QUARANTINE NOTICE

Reference number:	QN-31-1547V2	Issued: 15 September, 2021
Subject:	Install Spacers to the Roof Blind Assembly	
Model(s):	DBX	
VIN range:	Refer to the separately published list of affected Vehicle Identification Numbers (VINs)	
Applicable to:	All Dealers	
Distribute to:	Head of Business After Sales Manager Service Manager Sales Manager	Warranty Staff Technician(s) Parts Staff

Reason for this Quarantine Notice

Figure 1

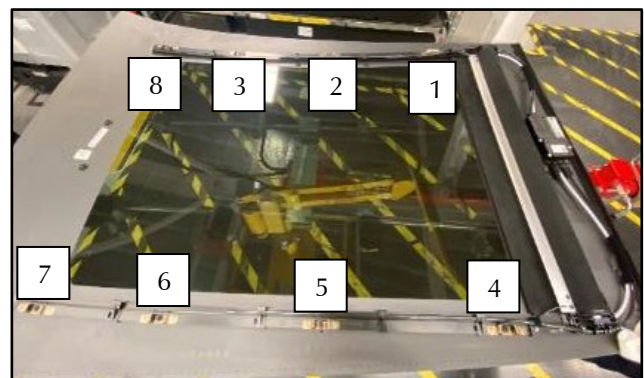
1. Remove the front overhead console assembly refer to (refer to Workshop Manual procedure 30.04.AD).
2. Remove the headlining (refer to Workshop Manual procedure 30.04.CA).
3. Complete steps 4 and 5 for the nuts in the sequence shown (refer to Figure 1).

Note: Start from the rear of the vehicle.

Figure 3

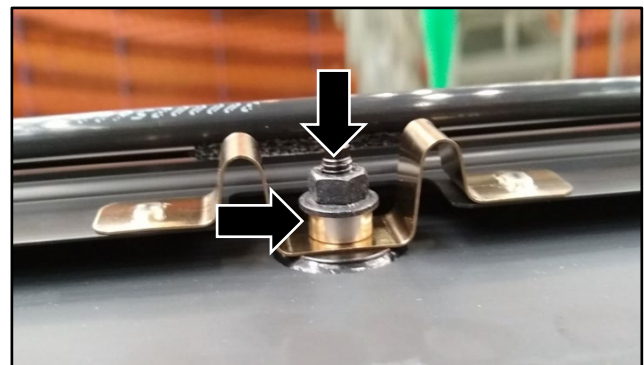
- Install the spacer to the stud, then hand start the nut onto the thread.

Use a manual torque wrench to torque the nut to 2.6Nm (refer to Figure 3).

CAUTION: DO NOT USE POWER TOOLS TO TORQUE THE NUTS. THIS CAN CAUSE DAMAGE TO THE GLASS.
